1) PAM vendor changed.

2) PCB minor Changed.(TX part)

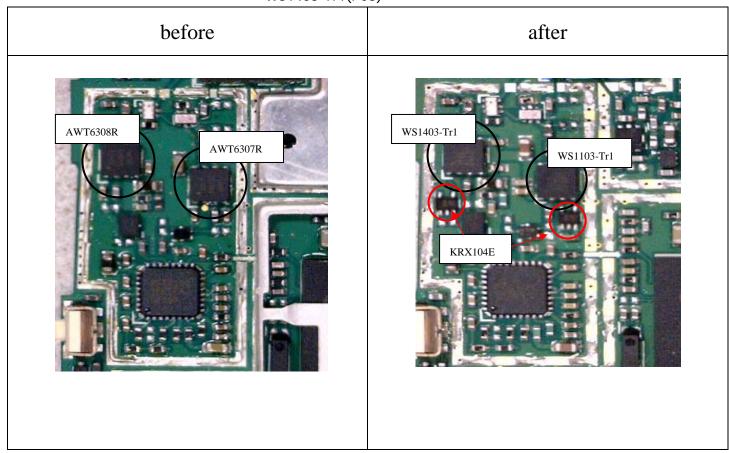
We have changed PAM vendor from Anadigics to Avago, because Anadigics has a shortage problem.

- Part No.(Anadigics) : AWT6307R(Cellular),

AWT6308R(PCS)

- Part No. (Avago) : WS1103-Tr1(Cellular), WS1403-Tr1(PCS)

Avago PAMs need external voltage regulation components and appropriate matching values.

(Transistor: KRX104E).

- Part No. (KEC in South Korea) : KRX104E

According to the PAM change, PCB was also minor changed.
